Disc Brake Rotor, Replacement
VAH, VHD, VN, VNE**FSB 511-010, Disc Brake Rotor, Replacement****(July 2021)**

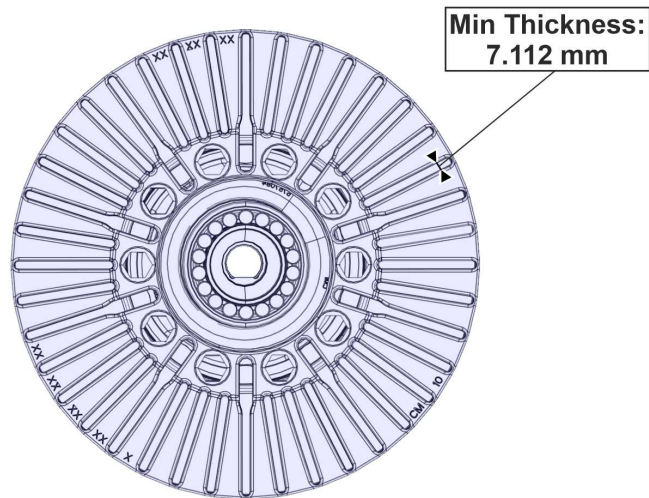
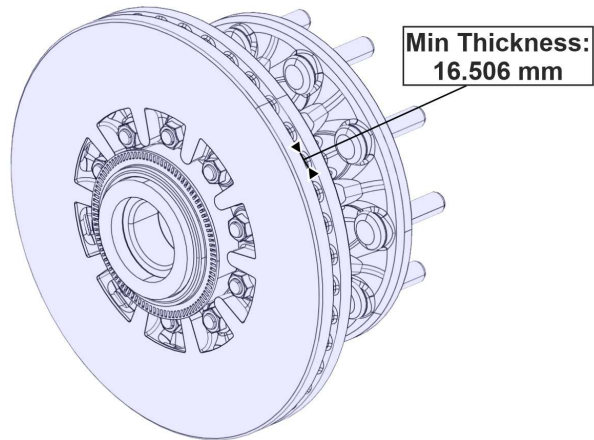
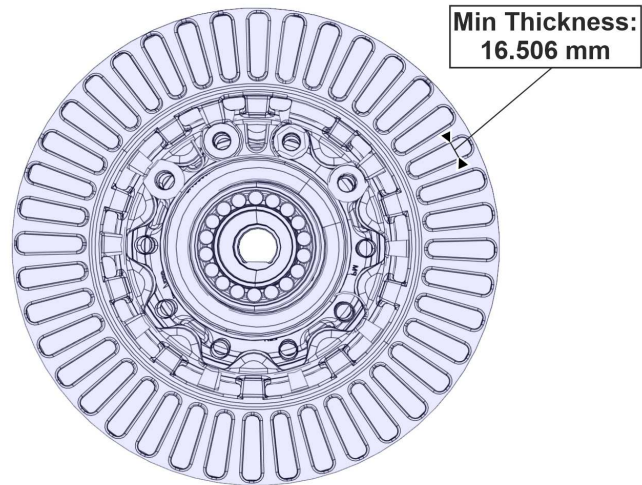
Beginning 11/16/2020, trucks were produced with reduced copper content brake pads/shoes. To cope with the higher operating temperatures produced by the new low/no copper friction material, the web size of the disc brake rotors was increased.

With the high copper content brake pads no longer being produced, care must be taken to correctly pair compatible parts per axle.

Trucks using a VOLVO proprietary rotor with a web thickness of less than 16mm must use a brake pad containing at least 5% copper. If 5% copper pads are not available, the rotors must be replaced with ones having the 16mm web.

IMPORTANT: The mounting flange of the updated rotor is thicker requiring longer mounting studs.

IMPORTANT: When replacing the disc brake rotor, the thicker rotor requires longer mounting studs. Longer mounting stud part number: 24019860.

IMPORTANT: The recommended best practice is to replace these rotors in pairs to ensure brake balance and reliability across the affected axle.
